**Subject: Drury Centre Stage 2 (Fast Track)  
Post Transport Conferencing Modelling Update**

**JOINT WITNESS STATEMENT (JWS) IN RELATION TO:**

**Topic: Transportation**

**Additional Info: Road 13 / Road 25 vehicle tracking**

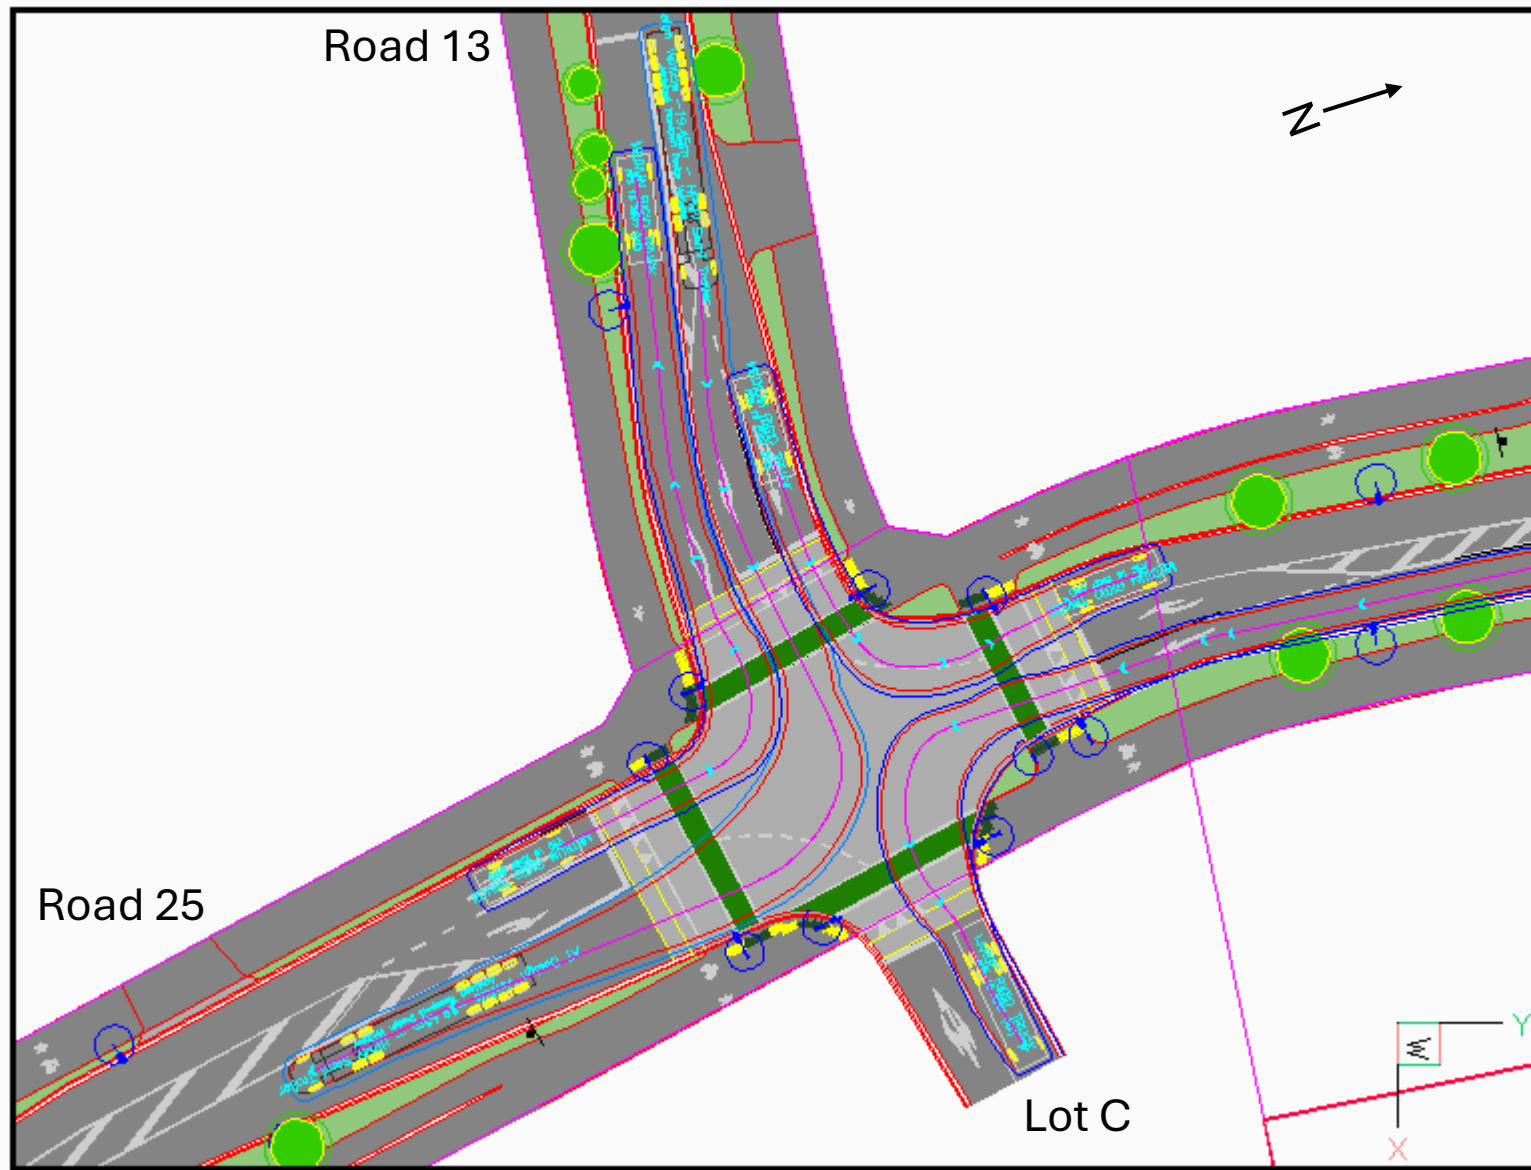
3.16.3 DH will circulate the results of vehicle tracking for articulated truck movements at Road 25 / Road 13. (Attachment A p. 34)

# Changes to NZTA design to achieve full 3,800vph without SH1DC

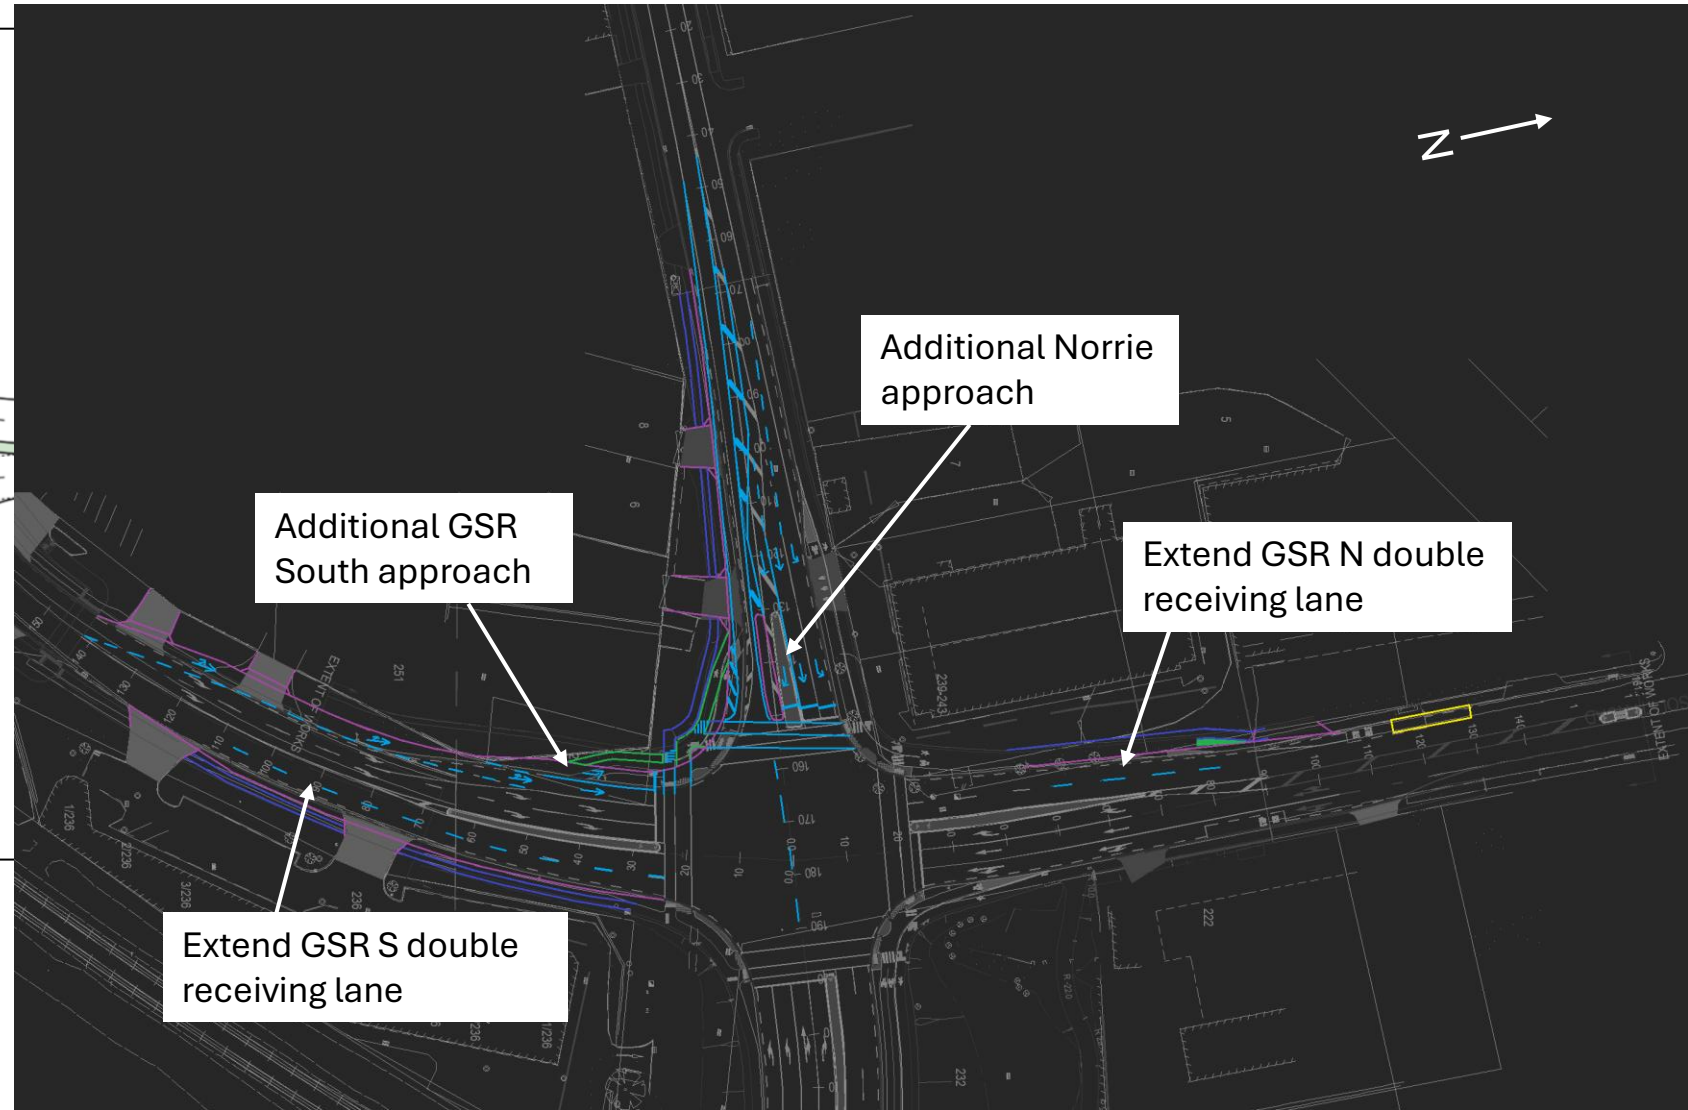
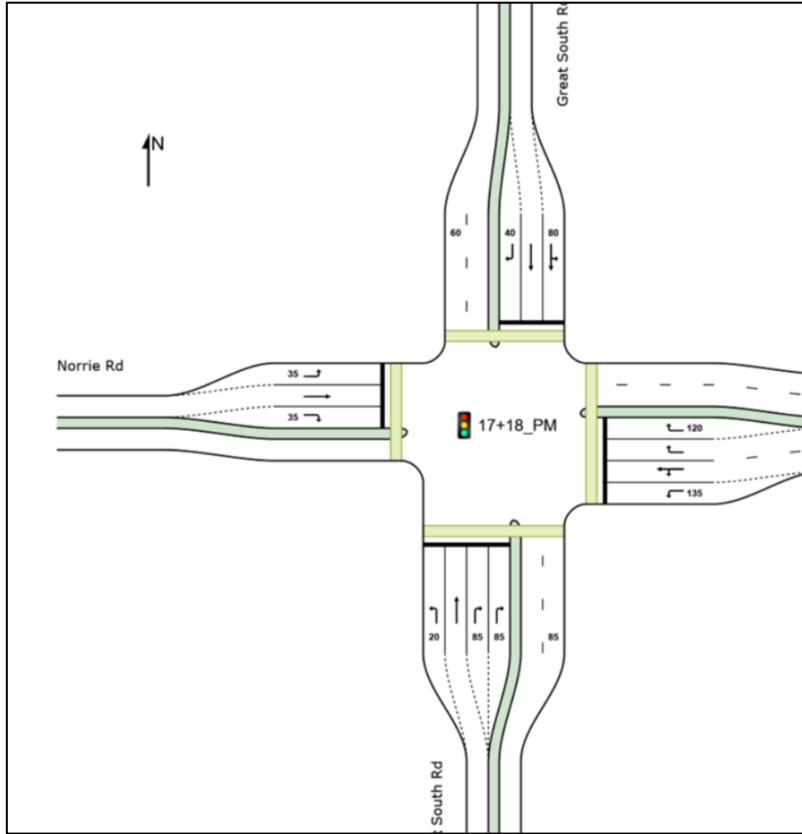
- 3.1.6 The proposed solution is to introduce a new condition requiring the NZTA/AT intersection (assuming it is built based on the current design) to be upgraded to include additional and longer approach lanes in accordance with the attached diagram (Attachment A – pp. 35 - 36) after the threshold of 2,700vph has been met. This will allow the full development up to 3,800vph.
